Appln No. 10/041,888

Reply to Office action of April 6, 2005

REMARKS/ARGUMENTS

Fig. 1

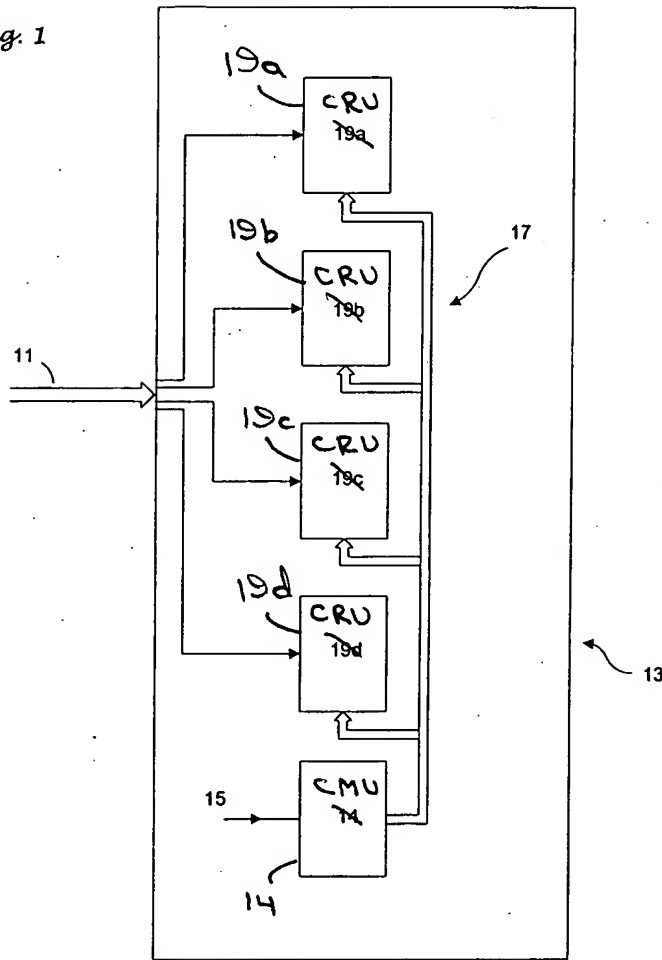
Turning now to the objections to the drawings, Figures 1-5 are objected to as not including text label in the various boxes. In addition, Figure 2 is objected to as not showing a clock distribution network 27, as indicated in the specification in page 4, lines 27-29.

Figure 1 is now amended to label the boxes identified by reference numerals 19a-d with the label "CRU". As indicated in the specification on p. 4, lines 8-10 "The clock distribution network couples the CMU to a plurality of clock recovery units (CRUs) 19a-d that are on the same chip as the CMU." Figure 1 is also amended to label the box identified by reference numeral 14 as "CMU". As indicated in the specification "A clock master unit (CMU) 14 located on the chip receives a reference clock signal 15..." Specification, p. 3, lines 34-35.
